**1601 WASHINGTON AVE**

AUGUST 1, 2025

# CHANGES TO PREVIOUSLY PRESENTED DESIGN

**RE: 1601 Washington Avenue (Parcel B) – ZP-2024-011946**  
**Response to Civic Design Review Key Recommendations**

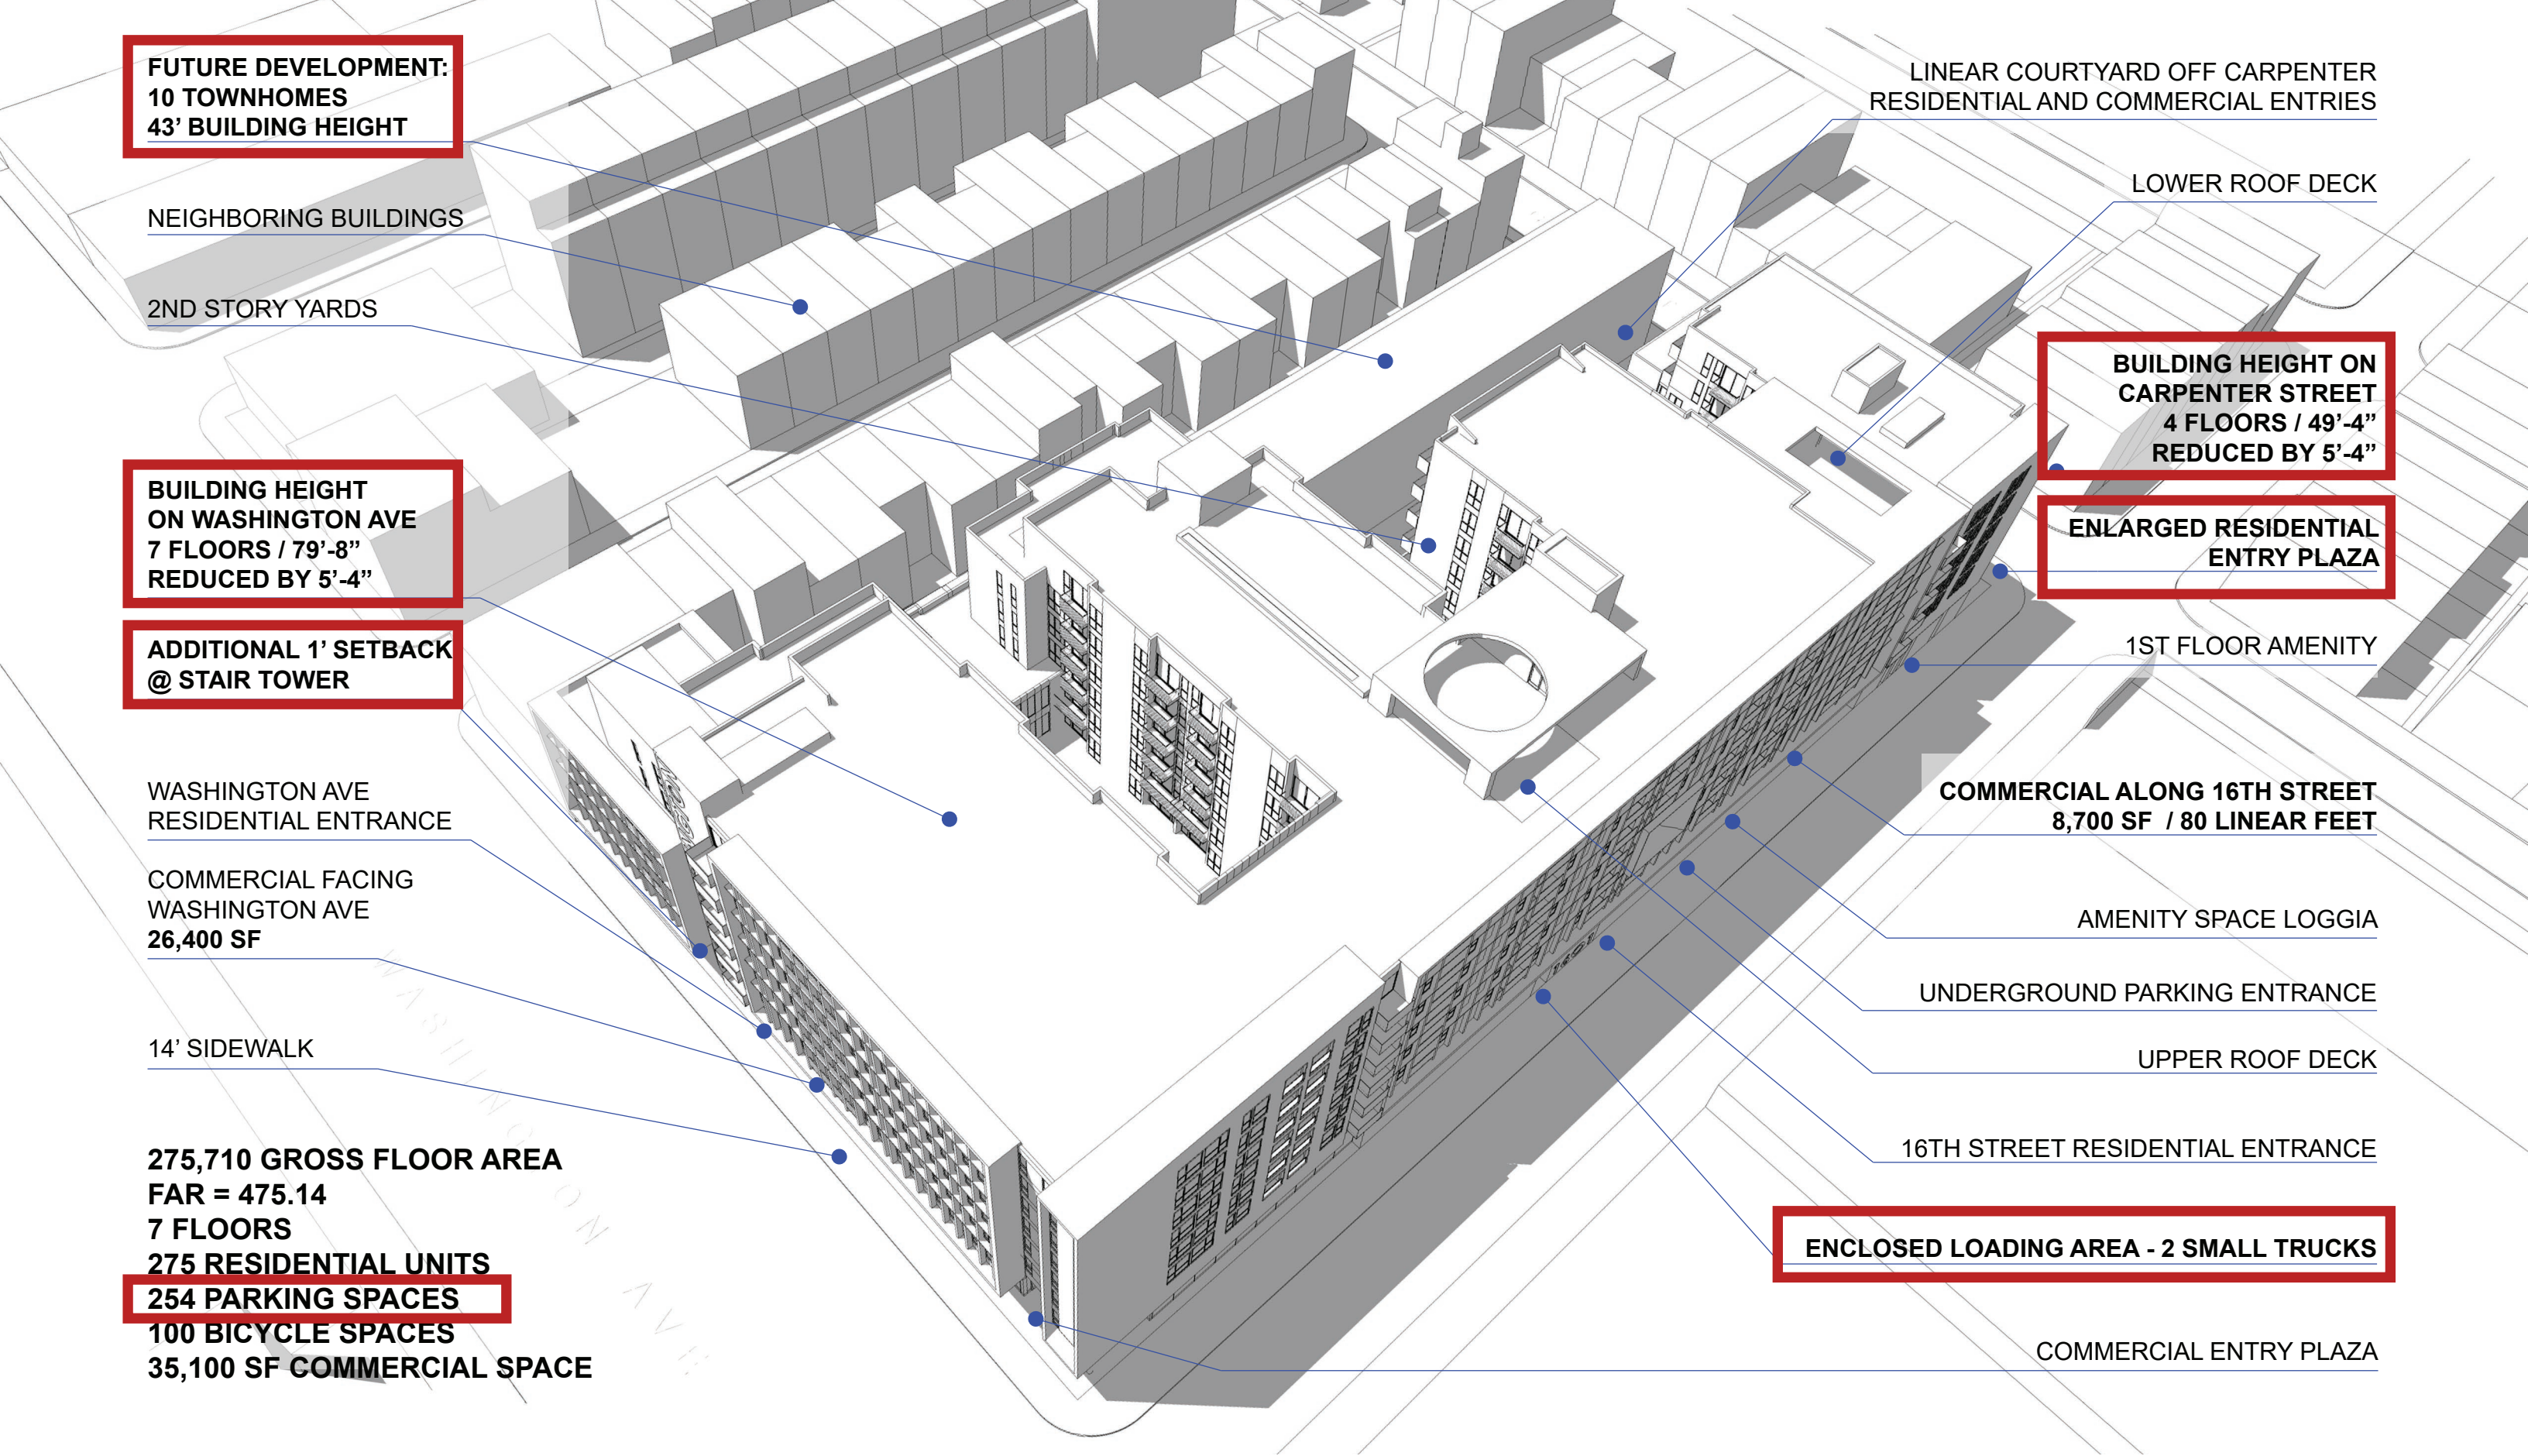
BY 5'-4" ON WASHINGTON AVE - FROM 85' TO 79'-8"  
BY 6'-4" ON CARPENTER STREET - FROM 56' TO 49'-8"

FITS TWO SMALL TRUCKS. DIRECT ACCESS TO RESIDENTIAL FREIGHT ELEVATOR

INCLUDING DESTINATION COMMERCIAL SPACE AT THE END BY THE RESIDENTIAL LOBBY

**EXPANDED SIDEWALK AREA AT THE ENTRY ON CARPENTER & 16TH**  
COMMERCIAL SPACE SET BACK 17' (PREVIOUSLY 6') TO CREATE A 29' WIDE SIDEWALK

**ADDITIONAL 12" SETBACK OF STAIR TOWER AT WASHINGTON AVE ENTRY**

**CAR LIFTS ADDED IN UNDERGROUND PARKING TO INCREASE CAPACITY BY 100 SPOTS**

**FINALIZED ADJACENT LOT REDUCED DENSITY & FOOTPRINT**  
10 TOWNHOMES IN PLACE OF 38 APT UNITS

**CONTINUOUS TREE TRENCHES ALONG 16TH STREET & CARPENTER**

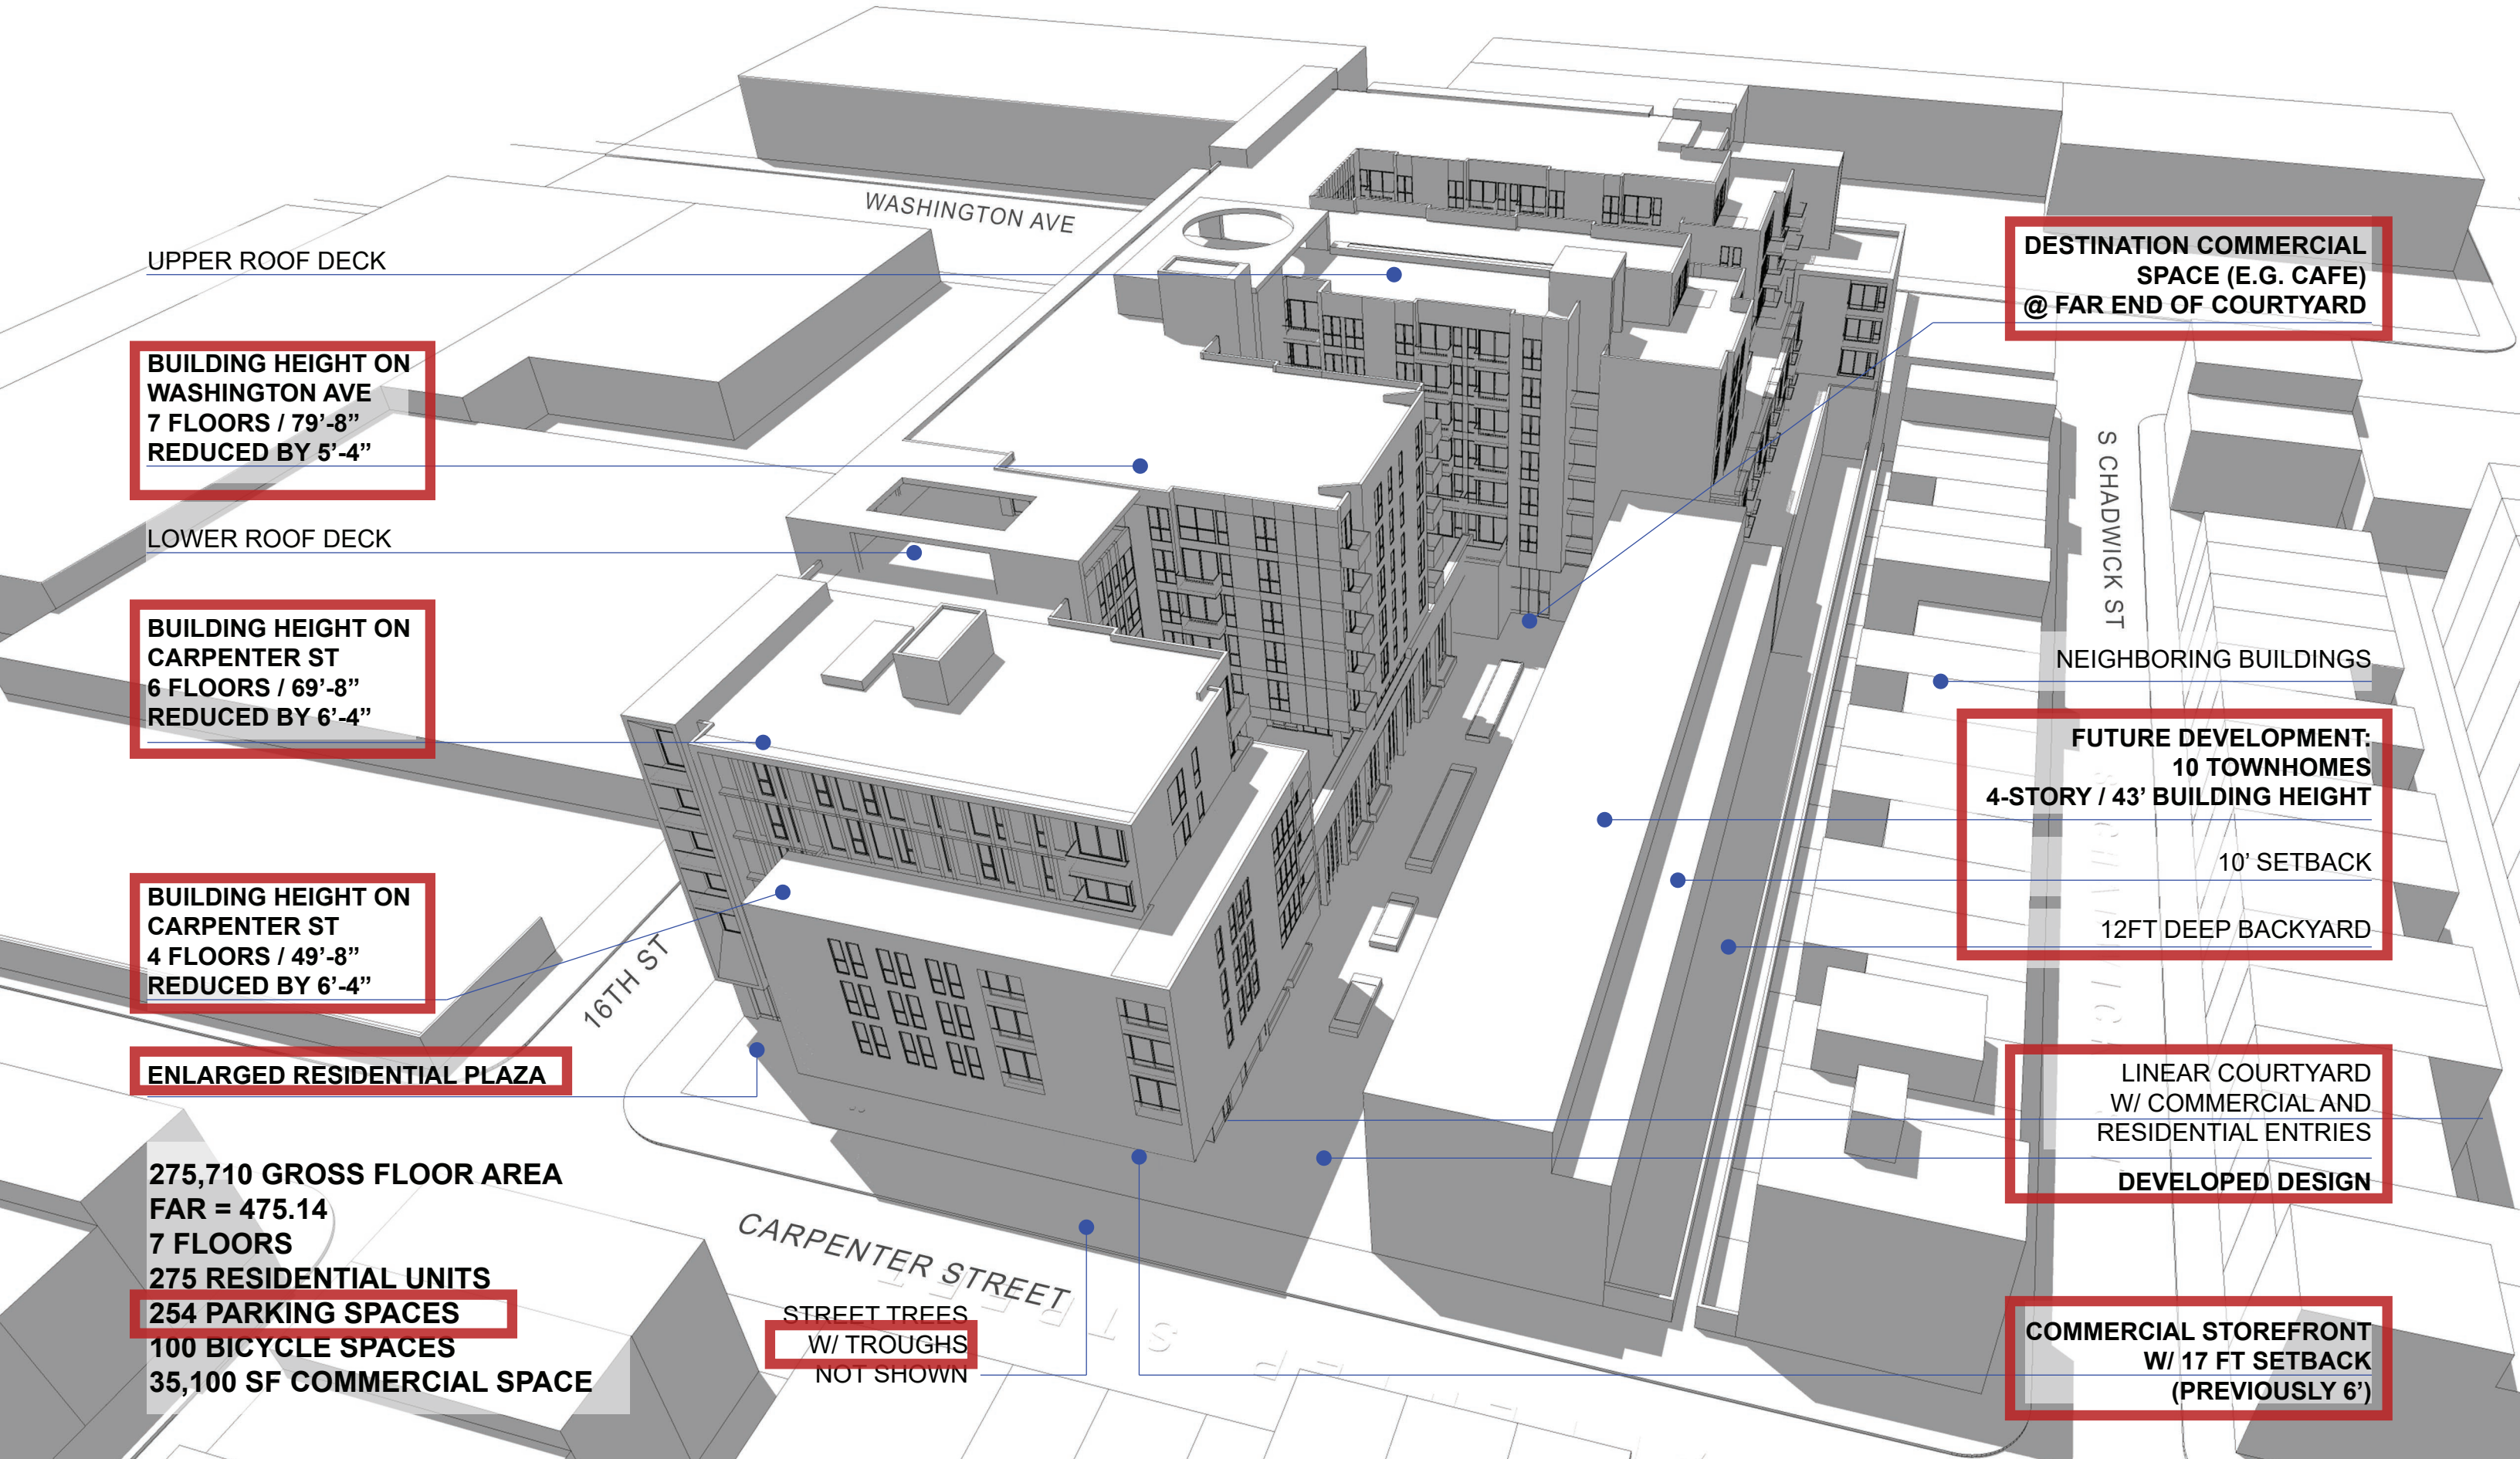
**BUILDING HEIGHT  
ON WASHINGTON AVE  
7 FLOORS / 79'-8"  
REDUCED BY 5'-4"**

**ADDITIONAL 1' SETBACK  
@ STAIR TOWER**

**BUILDING HEIGHT ON  
CARPENTER STREET  
4 FLOORS / 49'-4"  
REDUCED BY 5'-4"**

**ENLARGED RESIDENTIAL  
ENTRY PLAZA**

**ENCLOSED LOADING AREA - 2 SMALL TRUCKS**

# PROPOSED DEVELOPMENT

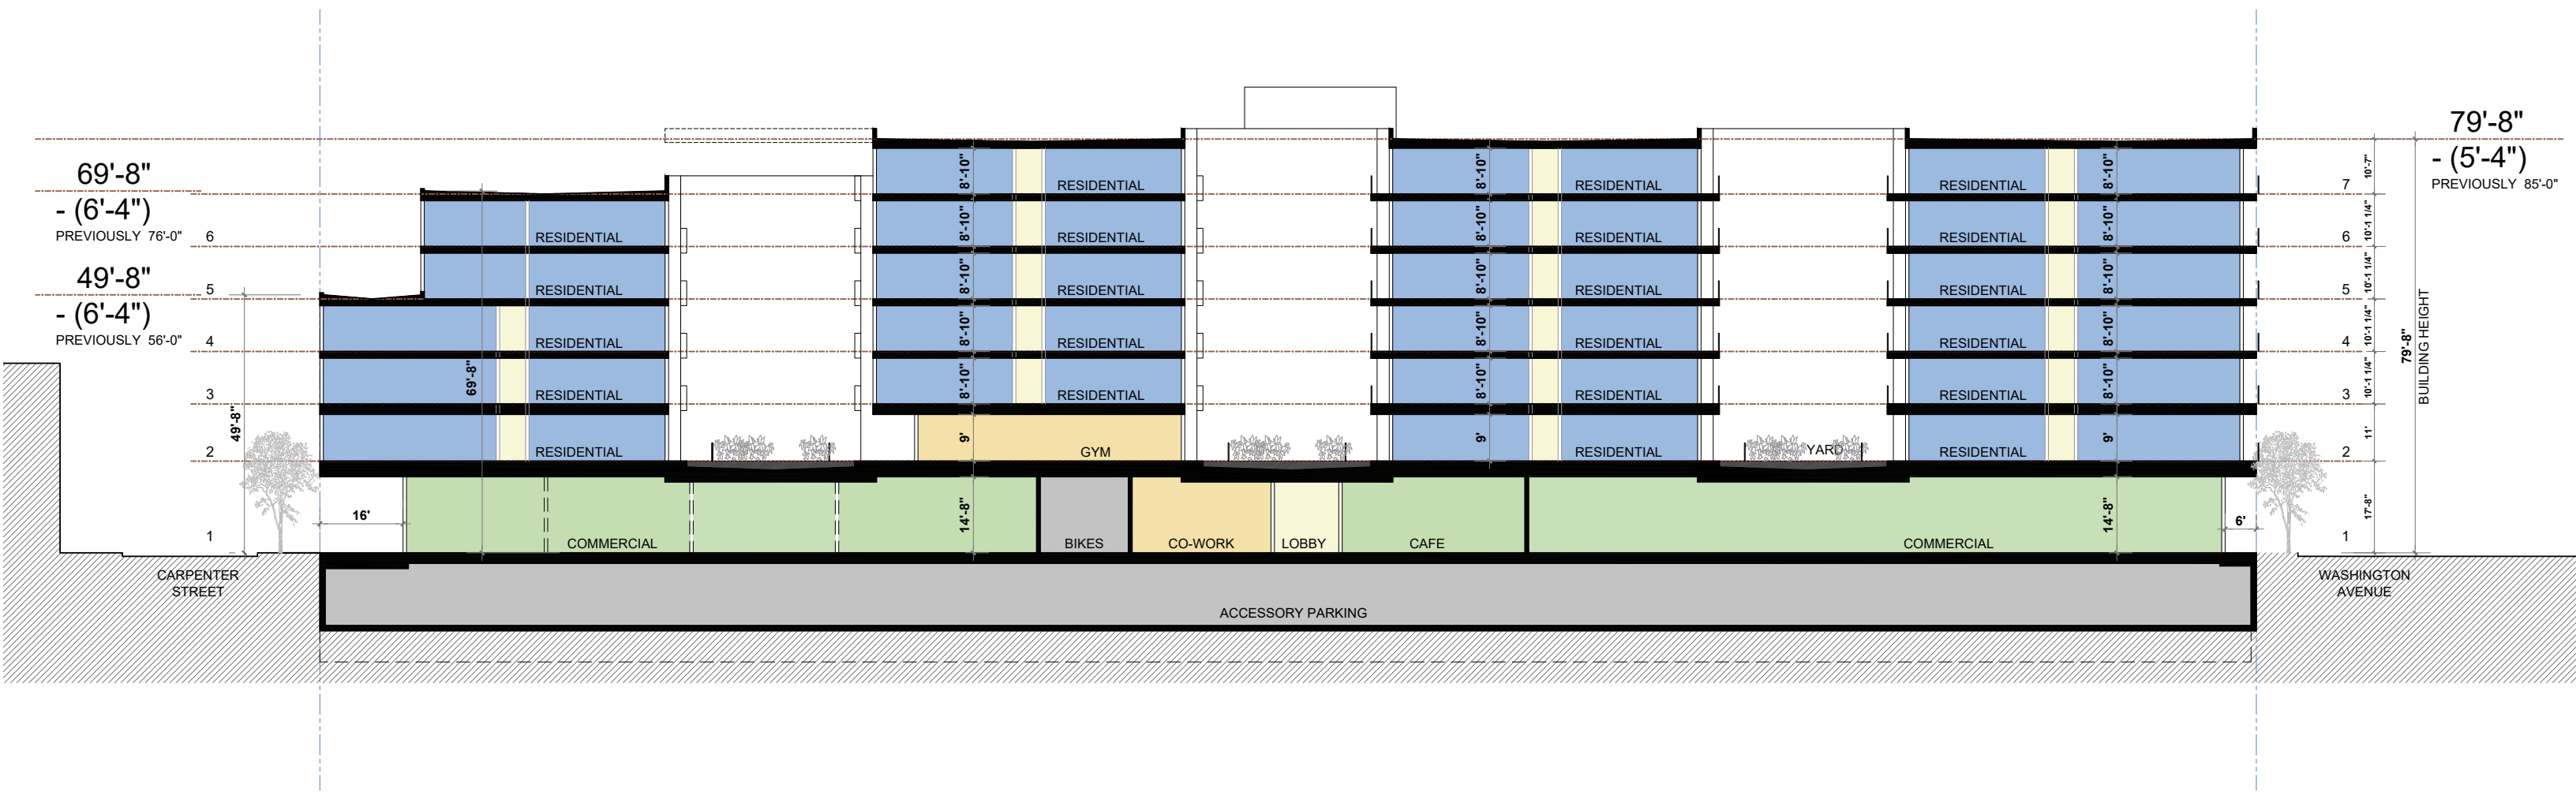
**BUILDING HEIGHT ON  
WASHINGTON AVE  
7 FLOORS / 79'-8"  
REDUCED BY 5'-4"**

**BUILDING HEIGHT ON  
CARPENTER ST  
6 FLOORS / 69'-8"  
REDUCED BY 6'-4"**

**BUILDING HEIGHT ON  
CARPENTER ST  
4 FLOORS / 49'-8"  
REDUCED BY 6'-4"**

**ENLARGED RESIDENTIAL PLAZA**

**DESTINATION COMMERCIAL  
SPACE (E.G. CAFE)  
@ FAR END OF COURTYARD**

**COMMERCIAL STOREFRONT  
W/ 17 FT SETBACK  
(PREVIOUSLY 6')**
